REGIONAL REVIEW NOTIFICATION

RE: Development of Regional Impact (DRI) Review – Town Old Peachtree DRI 3551

Name of Proposal: Town Old Peachtree DRI 3551 Submitting Local Government: Gwinnett County

Stream Buffers

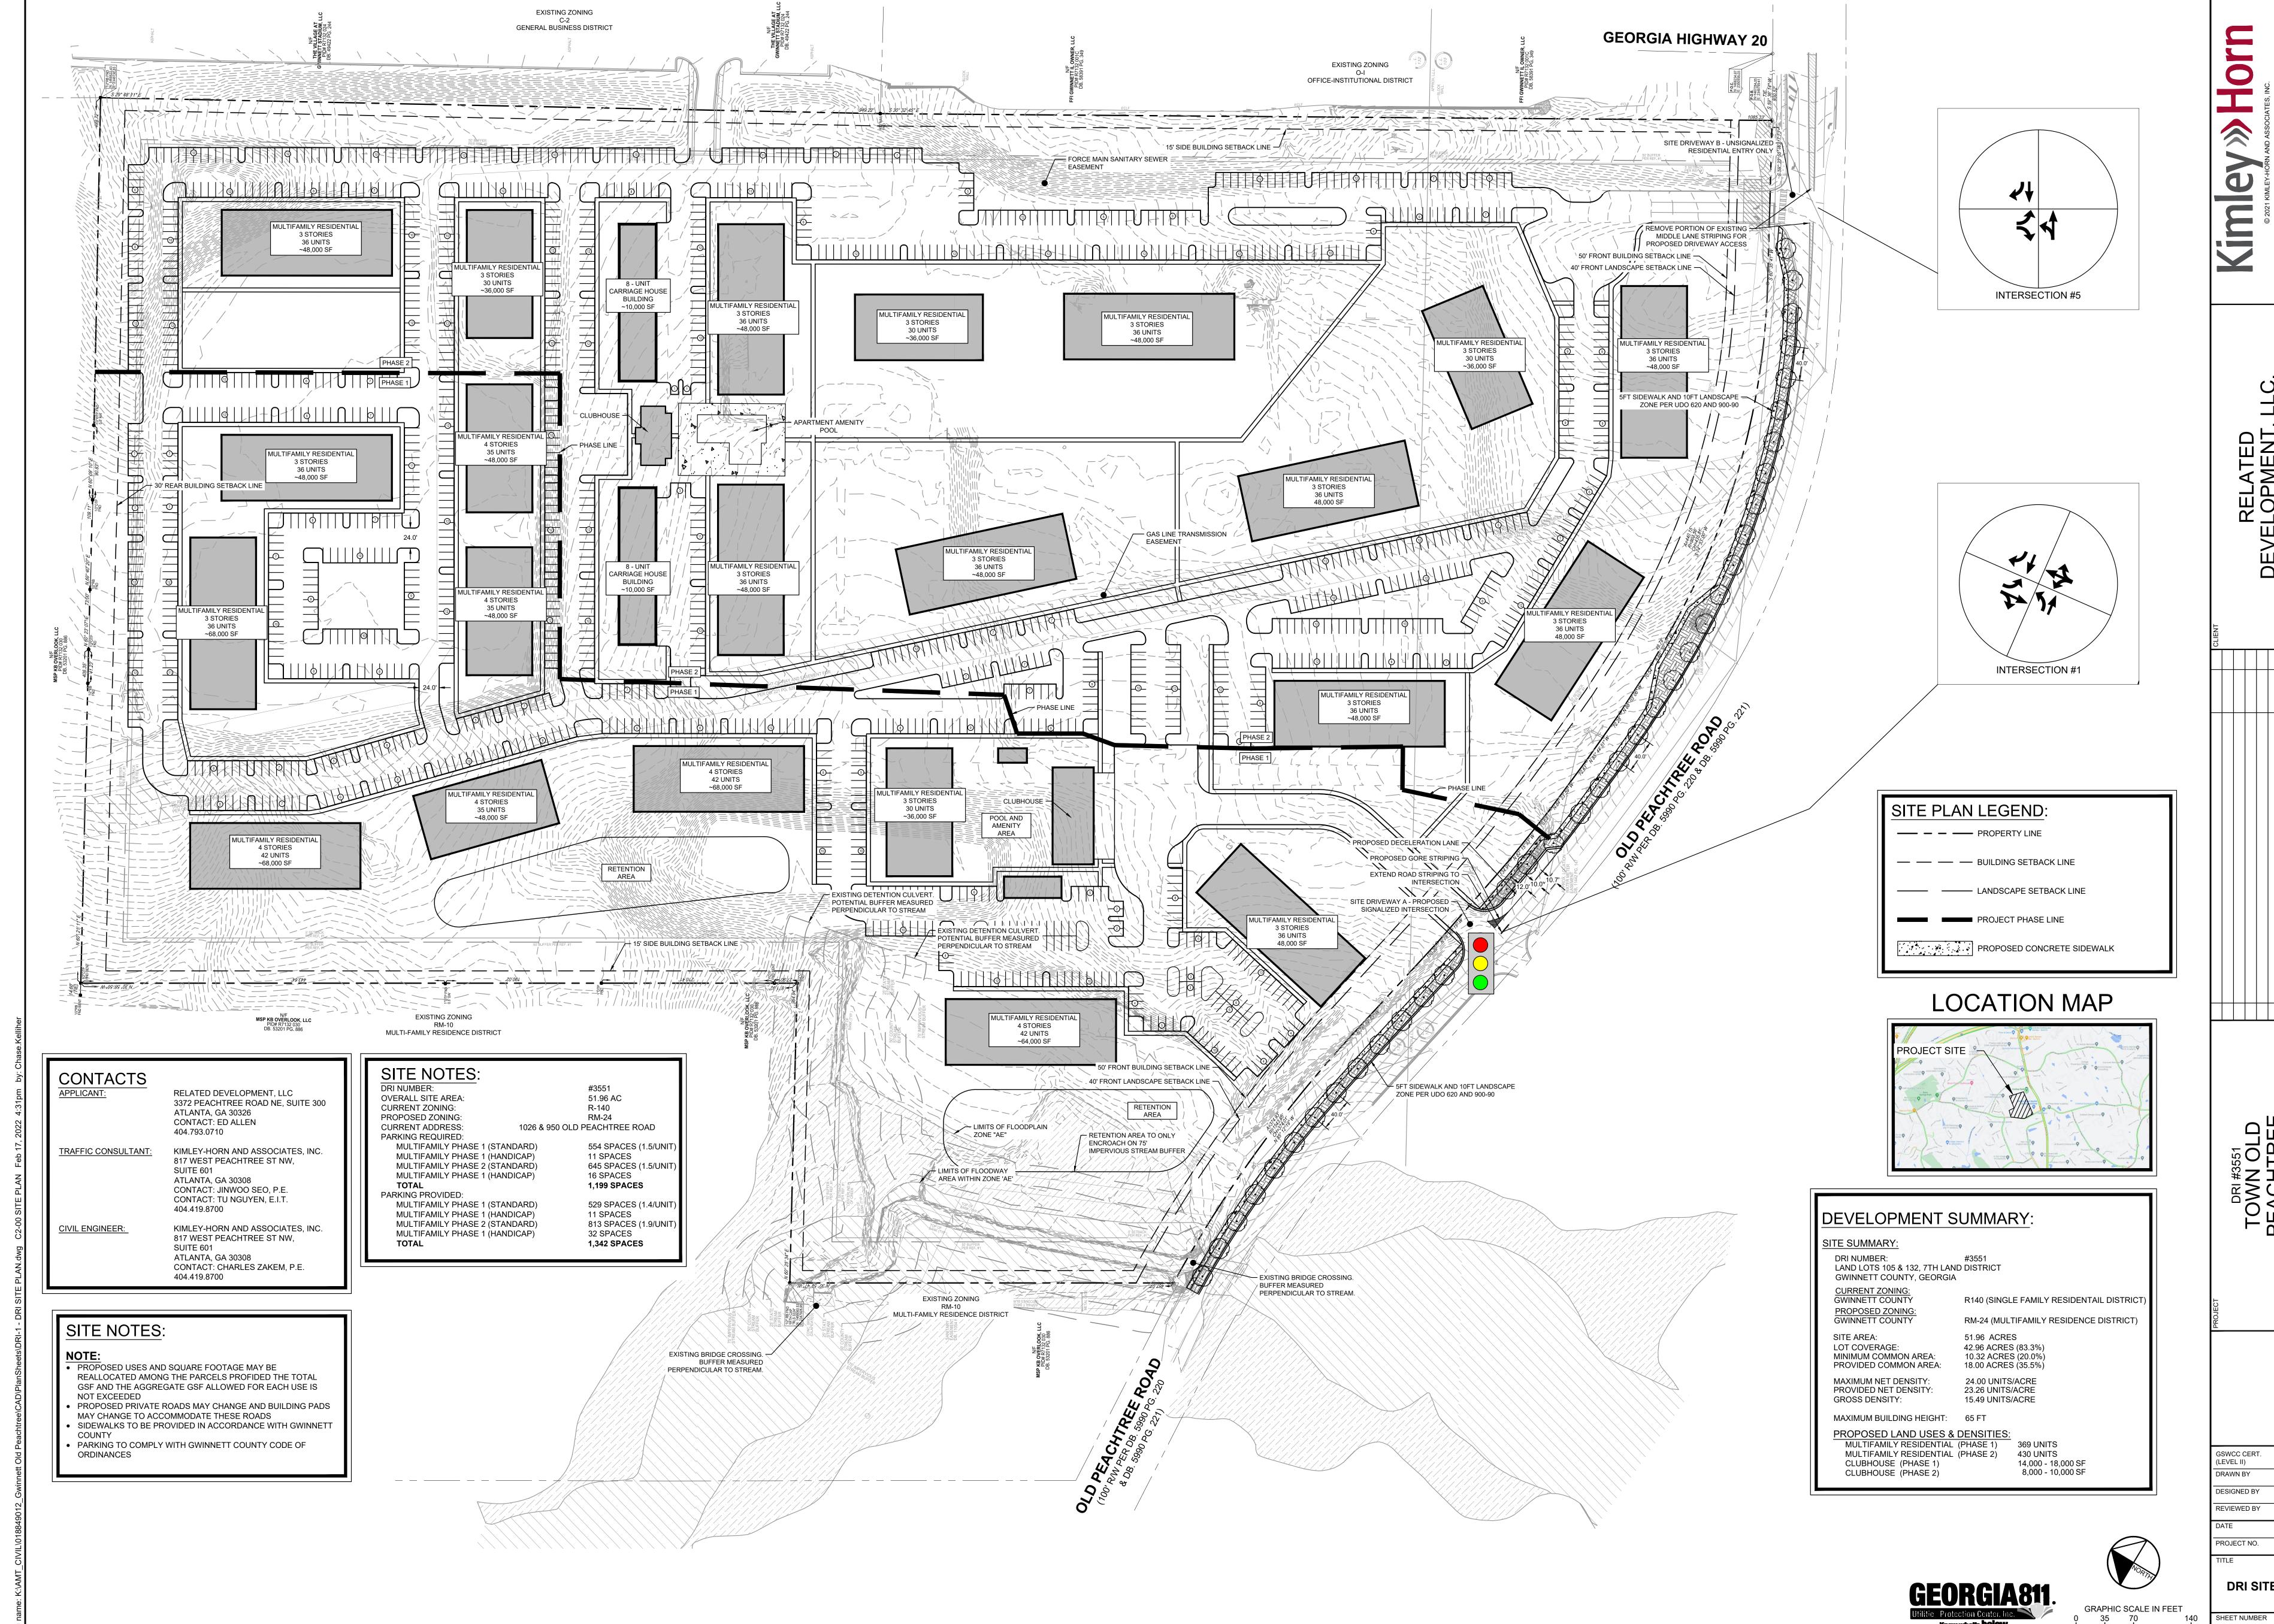
The USGS coverage and the project site plan for the project area shows an intermittent, unnamed tributary of Little Suwanee Creek along the western edge of the project property. The site plan also shows a tributary of the unnamed tributary starting within the property and then flowing westward to the mapped stream. Buffers that appear to be the Gwinnett County Stream Buffer Ordinance 50-foot undisturbed buffer and 75-foot impervious surface setback, as well as the State 25-foot Sediment and Erosion Control buffer are shown on both streams on the submitted site plan but are not identified. At the mapped headwaters of the smaller tributary, the buffers end and do not wrap around the headwaters point. This is an already developed area on the property. If this area above the headwaters is subject to the County's stream buffer ordinance and the State Sediment and Erosion buffer, the proposed development in the area may require variances. A retention pond is shown intruding into the buffers along the larger stream, and may also require variances Any unmapped streams on the property will be subject to the Gwinnett Stream Buffer Ordinance. Any unmapped waters of the State are subject to the requirements of the State 25-foot Erosion and Sedimentation Act buffer requirement.
